1.0 Thomas Peacocke. site: Plutus Developments RR/2017/1778/P

8.00 Sandrock Marine, Rock Channel RR/2020/334/P

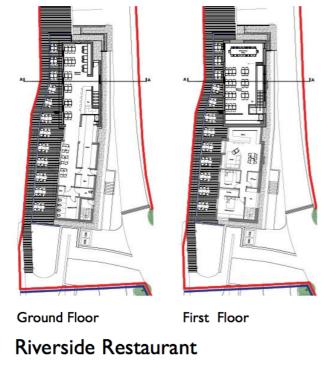
What is not picked up is that the public area does not change and that they have just reduced the number of seats drawn on the plan. What is to stop whoever runs it in the past just putting in more tables . That is why the parking requirement is based on an area not the number of covers.

The upshot is that we have consent for two restaurants this and that proposed at the Riverside as part of the Bridgepoint Studios. If you calculate the relevant areas both inside and out on the terraces you will see that against ESCC standards the parking is inadequate and is likely impose pressure on the surrounding area if both restaurants are successful.

Inside public space	132 sq m	I car space for 5 sq. m = 26 spaces
Outside terrace	112 sq.m	I car space for 5 sq. m = 22 spaces

Inside public space	90 sq m	I car space for 5 sq. m = 18 spaces
Outside terrace	80 sq.m	I car space for 5 sq. m = 16 spaces

Total car parking requirement based on ESCC requirement of I space per 5 sq.m and not allowing for staff, is for indoor public space 44 spaces and for outdoor space 38, in total 82 spaces. Currently allowed under planning consents 17 in total for visitors and staff.

Even if the lower standard of 1 space per 10 sq.m was applied these two restaurants would require 41 spaces plus staff parking. Which represents a still considerable shortfall.

I spoke to Rob Pollard on Friday and we discussed this site and the minor amendments. The moorings are intended to be boat parking rather than accommodation needing car parking and the covers in the A3 use are reduced from the original. (98 to 68) Given that the other elements of the application are the same, I would not wish to object, and there is a preference that the supported level of parking provision remains.
